Redwood Miamisburg North Springboro Pike OH Pl Construction Site Plan

BUILDING G

- 1 Meadowood Left
- 1 Forestwood Left
- 1 Meadowood Right

A2.26
57 OF 137

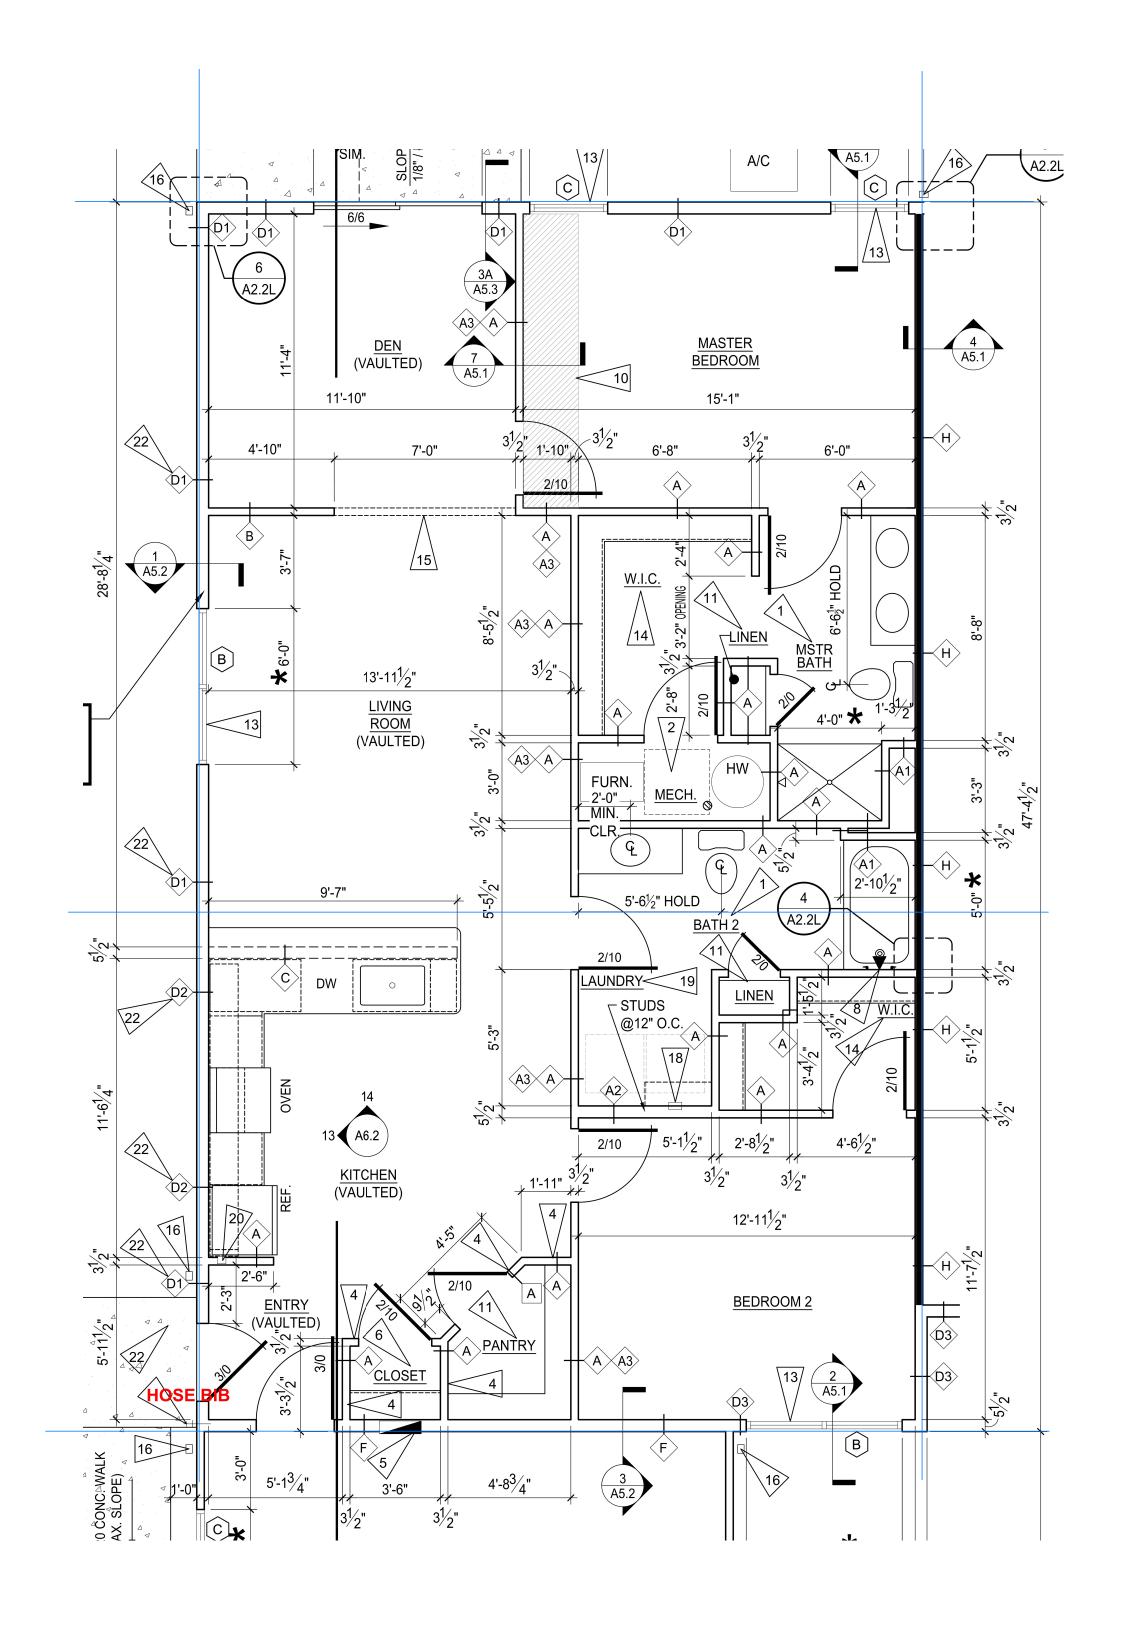
NOTES: MUST install tub boxes for tub and shower traps!! Wait until gravel prepped 28' Run trunk line for sewer at 31' from rear of unit 10" Lave 11-6 1/2" Toilet 1-6 1/2" Toilet 5-7" Floor Drain Shower 1-3'-4"

Clean Out \bar{n}

-10'-10"

Washer 👆

Meadowood Right WATER

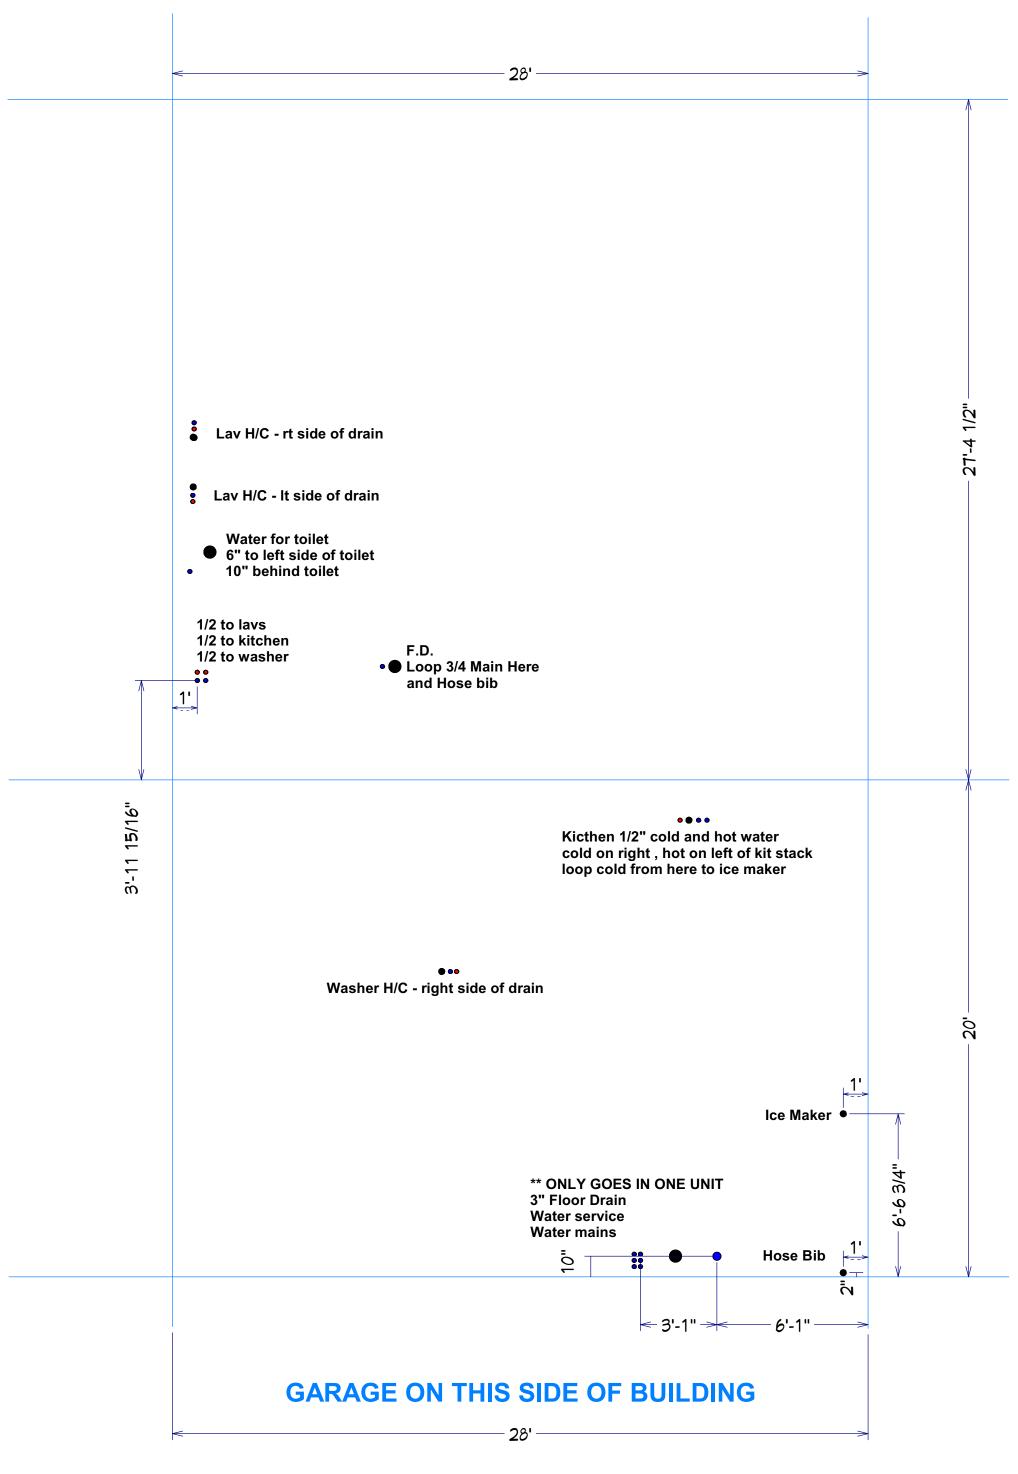
Kicthen

** ONLY GOES IN ONE UNIT 3" Floor Drain for Backflow

Forestwood Left PVC

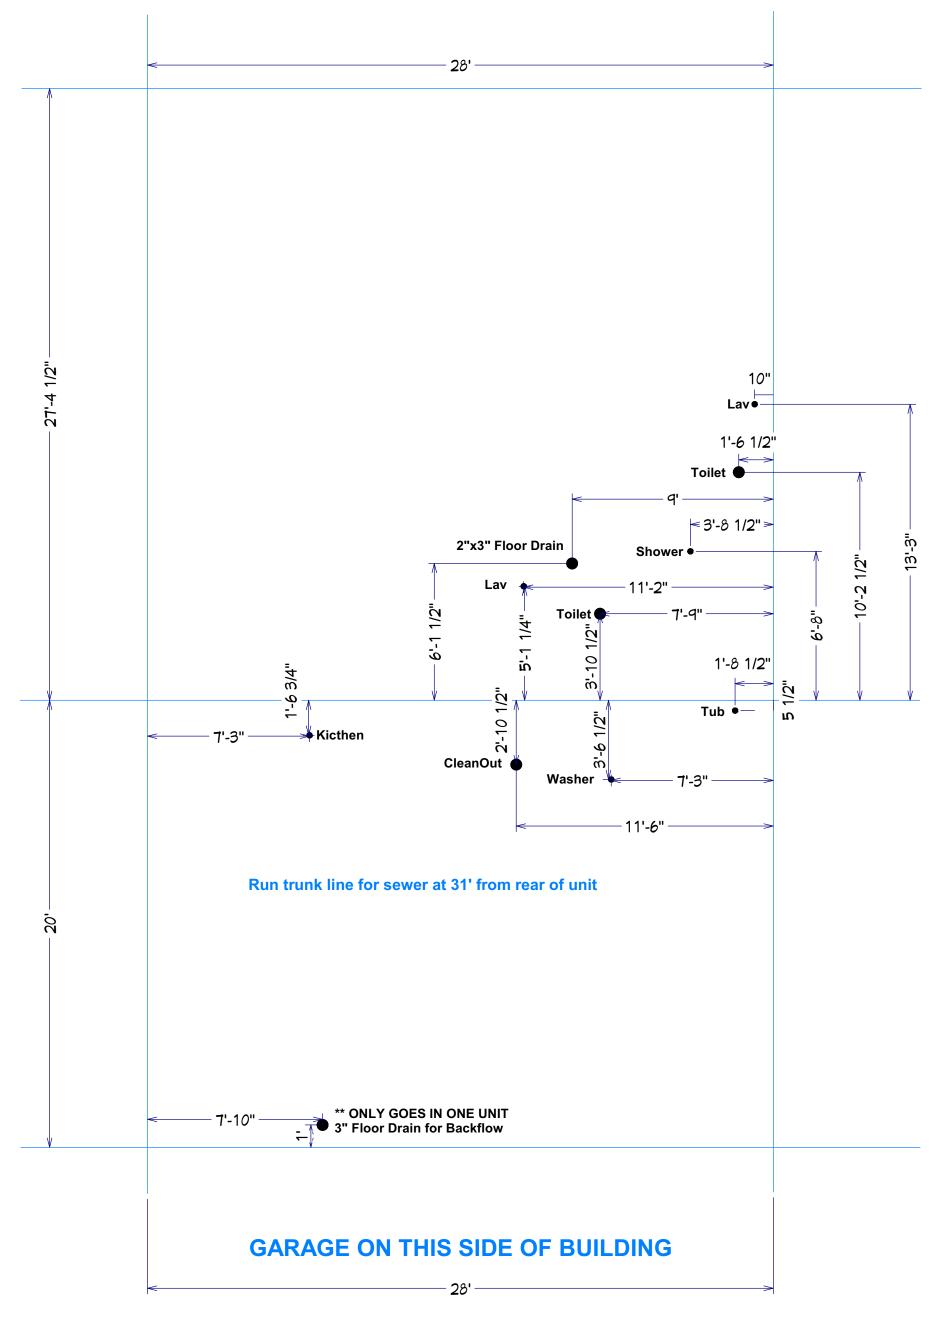
MUST install tub boxes for tub and shower traps!! Wait until gravel prepped
